## Application for Land Use Action Check All That Apply

Applicant: Mildren Design Group. Contact: Jeff Wilder Phone: 503-244-0552  
 Applicant Address: 4875 SW Griffith Drive, Suite 300, Beaverton, Oregon 97005  
 Owner: Theo Treske, theo@treske.com Phone: 503-625-2821  
 Owner Address: 14140 SW Galbreath Drive, Sherwood, Oregon 97140 E mail: \_\_\_\_\_  
 Contact for Additional Information: Site Review Contact: Will Grimm, First Forty Feet; will@firstfortyfeet.com

Street Location: SW Galbreath Drive, Sherwood, Oregon 97140  
 Tax Lot and Map No: TL 700, 2S/28BC  
 Size of Property(ies) 1.96 acres

# TRESKE PRECISION MACHINING

**C3.0**

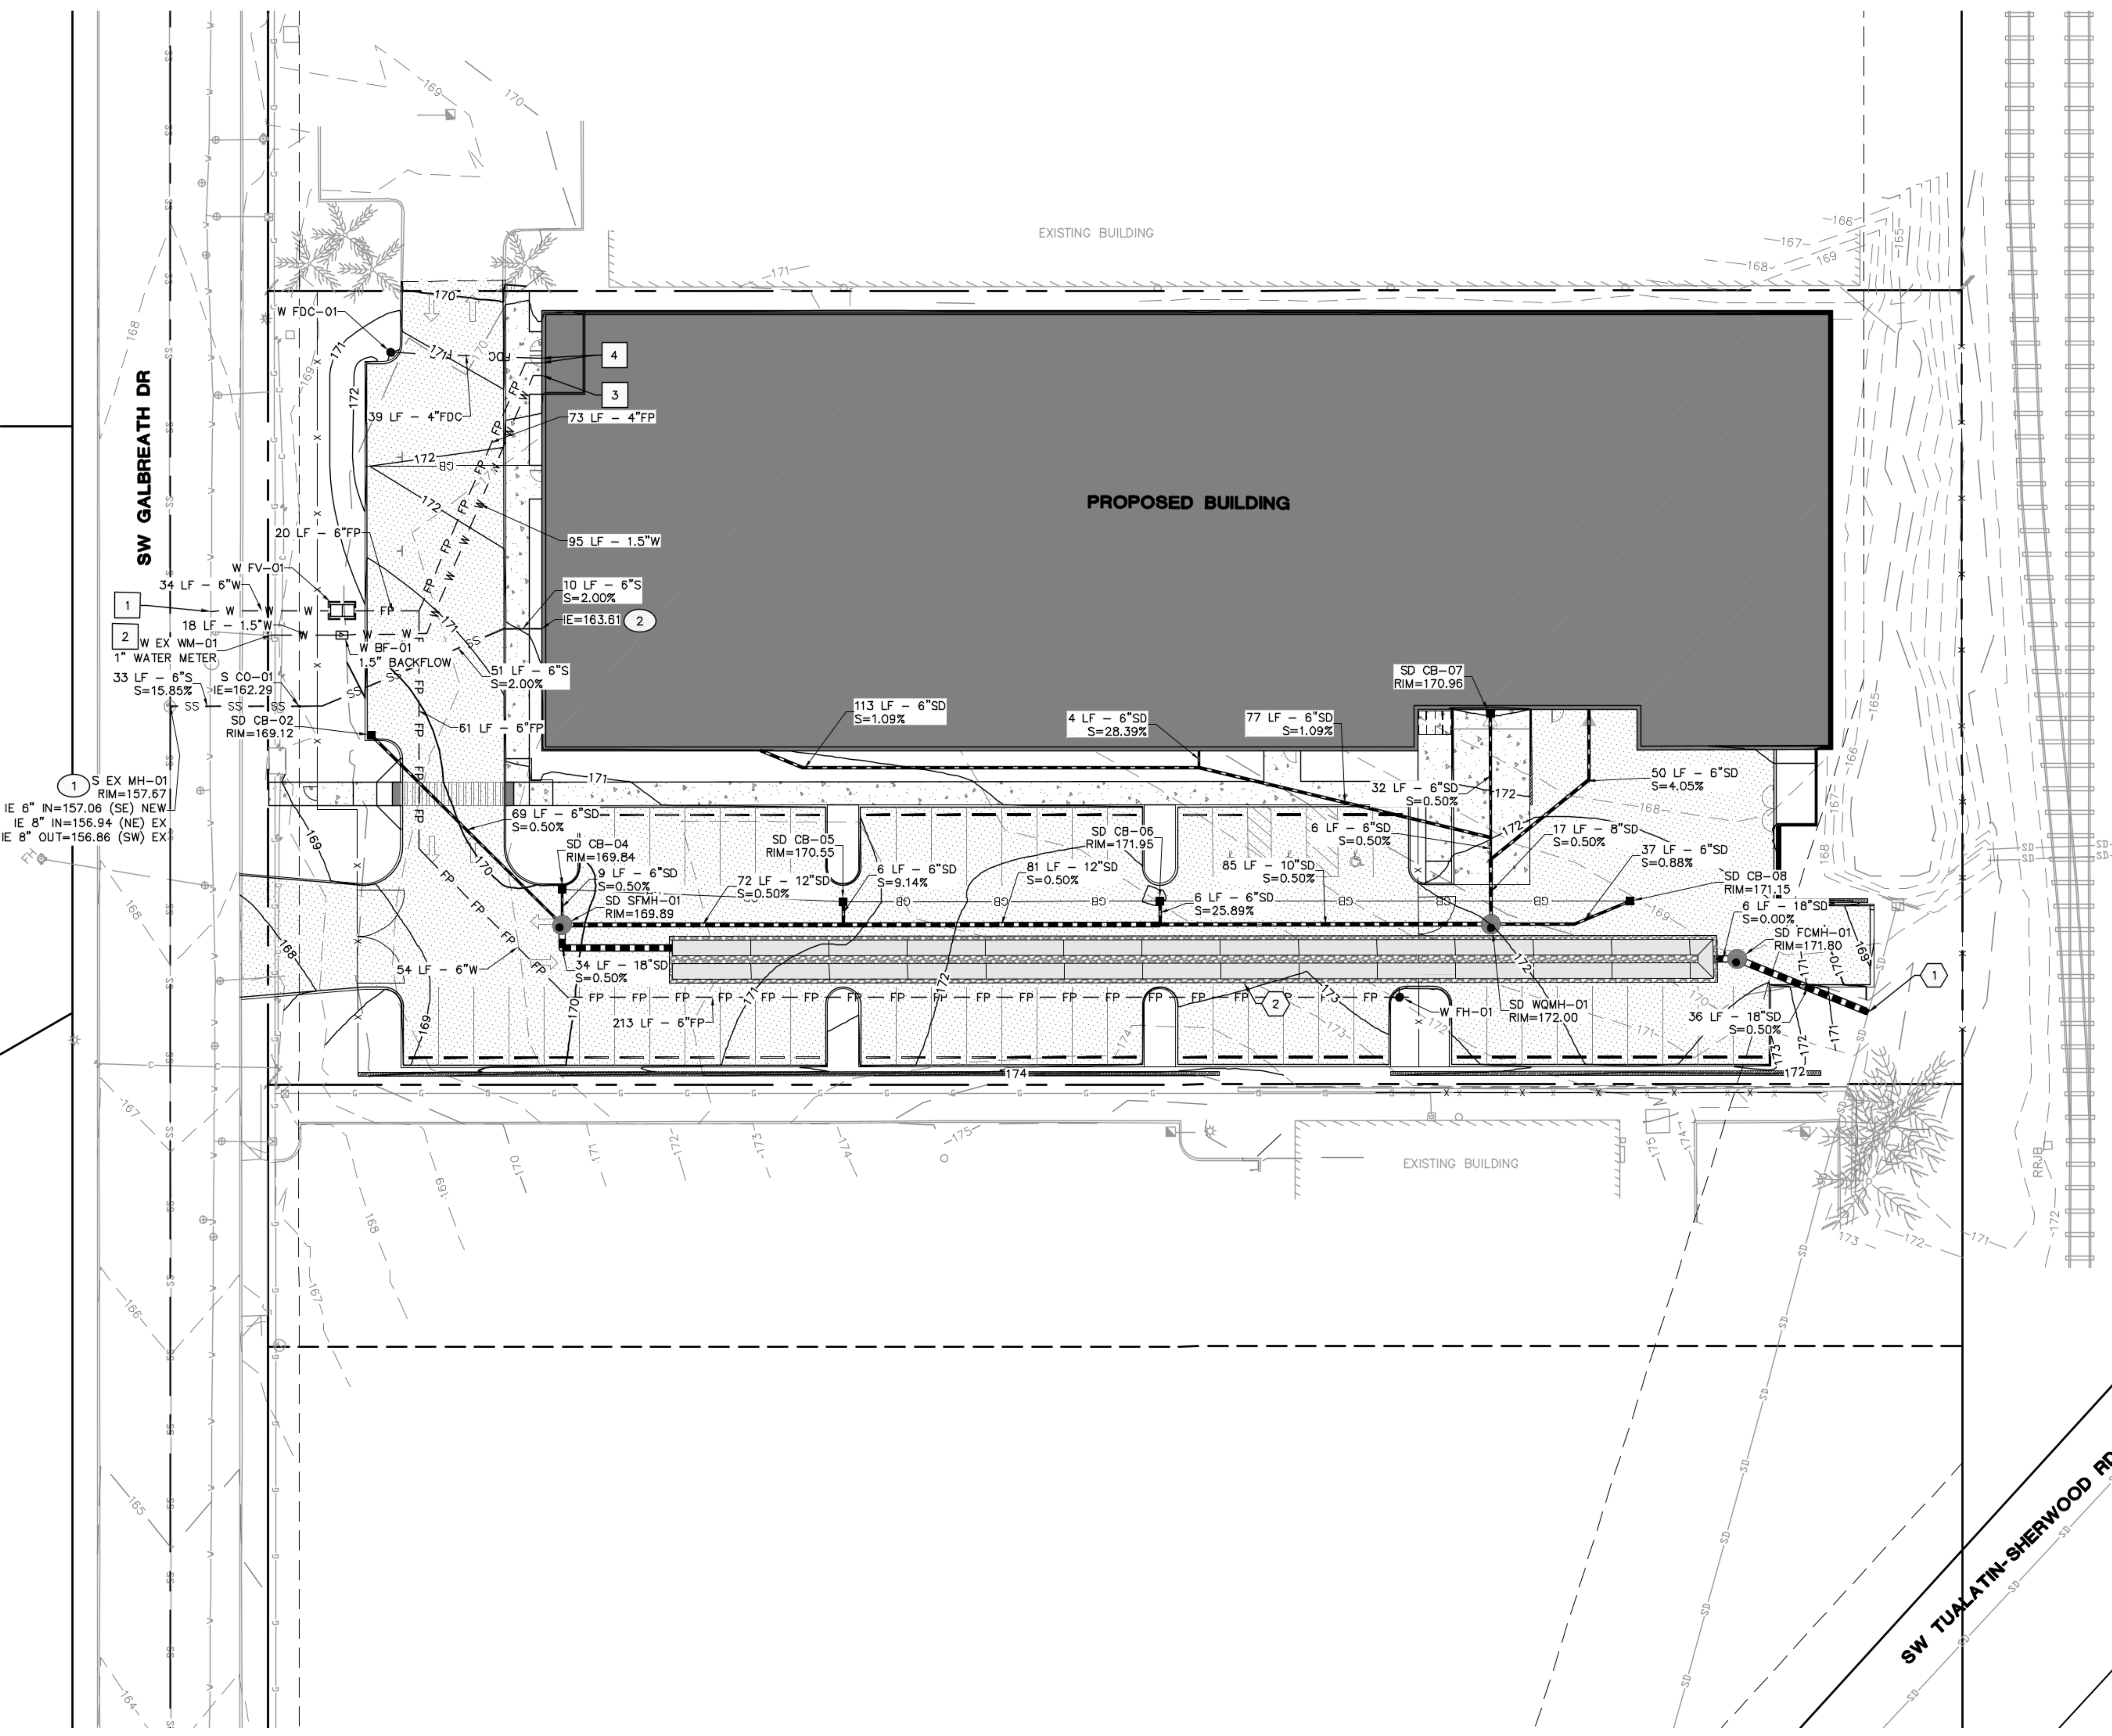
- a. Response: 18” manhole is shown on Civil Sheet C3.0 at connection to Existing Storm System.
3. “Note: The FDC will need a fire hydrant within 100 feet. The hydrant across SW Galbreath Drive will likely not be acceptable to TVF&R for this purpose. Will likely need to slide FDC to northeast to be within 100 feet of the existing fire hydrant in front of existing Treske site.”

- a. Response: As shown on Civil Sheet C3.0, the FDC has been relocated to within 100 ft of the existing fire hydrant on Galbreath Dr.

## 1 SITE SURVEY

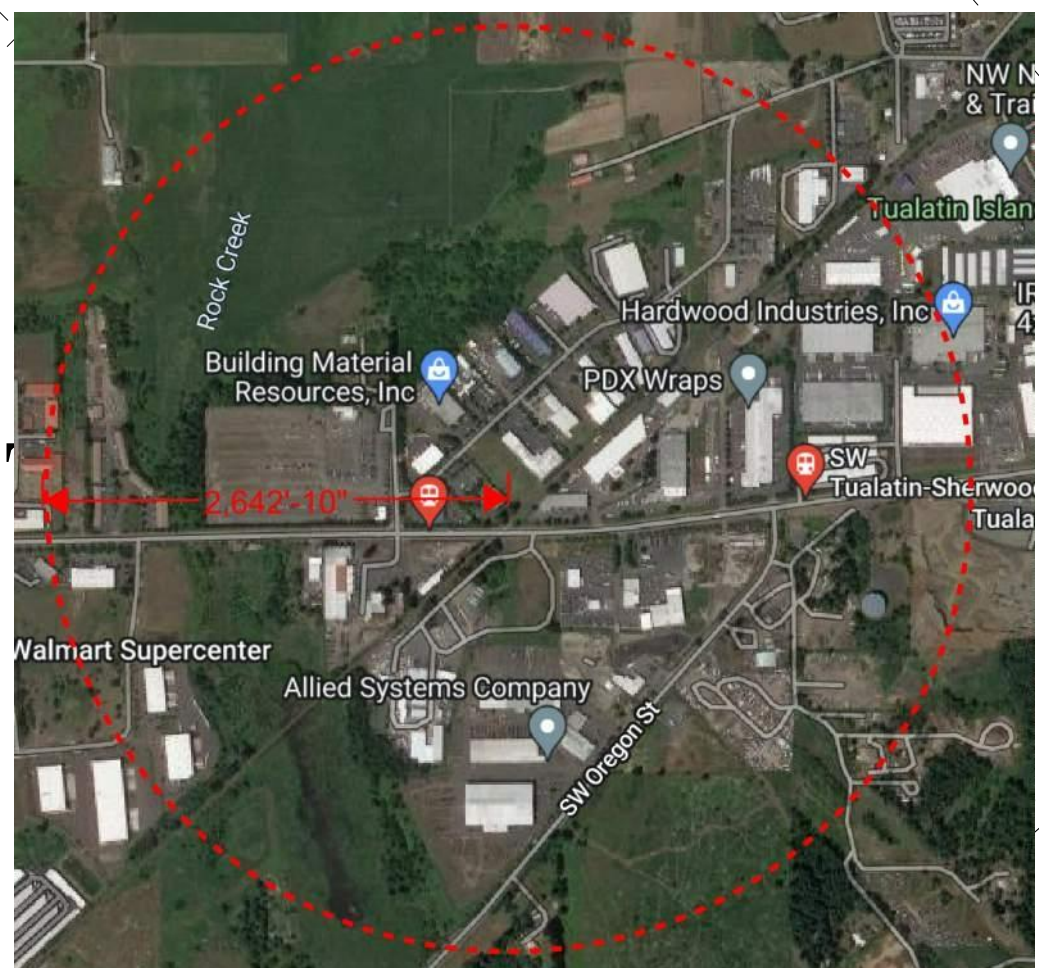
1. "Remove references to "South Line Lot 13" on adjacent DMV property on plans. Clearly label the existing property line per Record of Survey 28066."
  - a. Response: Site Survey on Sheet G1.0 has been revised to omit reference(s) to "South Line Lot 13".
2. "Show existing right-of-way line per Dedication Deed 2009-066843 (Washington County) on plans. Show existing public utility easement per Easement Document 2009-066844 (Washington County). Adjust Site Plan based on corrected property line."
  - a. Response: Site Survey on Sheet G1.0 has been revised to show ROW Dedication per Dedication Deed 2009-066843 and PUE per Easement Document 2009-066844.
3. "Label depth of proposed parking stalls on plans."
  - a. Response: Typical parking stall depths (and widths) are shown on Sheet A1.1.
